CO-ORDINATION OF NOTIFIED BODIES
PPE Regulation 2016/425

PPE-R/11.090
Version 1

RECOMMENDATION FOR USE

Key words:
EN 362:2004, latch distance from connector body

Picture 1: distance to consider

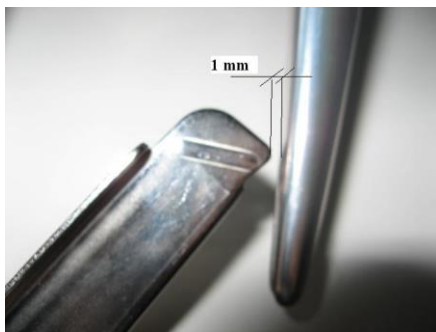
Question:
Point 4.4.1 of EN 362:2004 standard says that "the gate locking feature shall withstand a force of $(1 \pm 0,02)$ kN without separating from the latch by more than 1 mm". Which is the correct interpretation?

Solution:
The distance of the part of the latch of less than 1 millimetre from the body of the connector must be considered as the distance of the latch teeth (picture 1) and not of the part of the latch which touches the body (picture 2).
